# **FIRE SAFETY INSPECTION REPORT**

**ARUNIMA APPARELS LTD.  
RISING COMPLEX, PLOT# I/10, BLOCK-K, RUPNAGAR  
I/A, SECTION-2**

**ACCORD**  
on Fire and Building Safety in Bangladesh

March 25, 2014

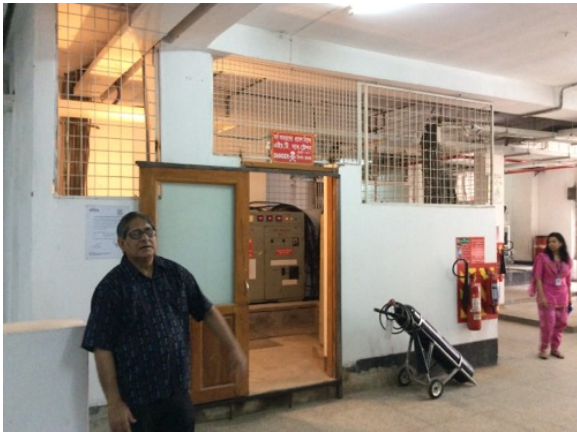
F-1	Fire Rated Construction	The boiler rooms on the fifth floor are not separated by fire-rated construction due to non-rated doors and penetrations.	Separate the boiler rooms by a minimum 2-hr fire-rated construction. Seal and/or protected all openings to maintain the required fire separations	Within 3 months
-----	-------------------------	---	---	-----------------

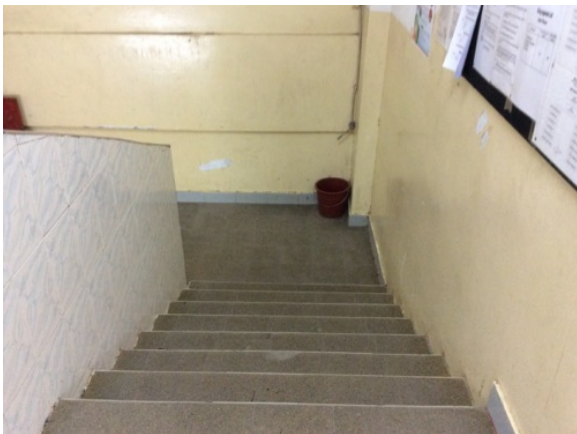
F-13	Egress	The width of egress aisles along the east wall is less than 36-in. on all factory floors.	Provide minimum aisle widths of 36-in.	Within 3 months
------	--------	---	--	-----------------
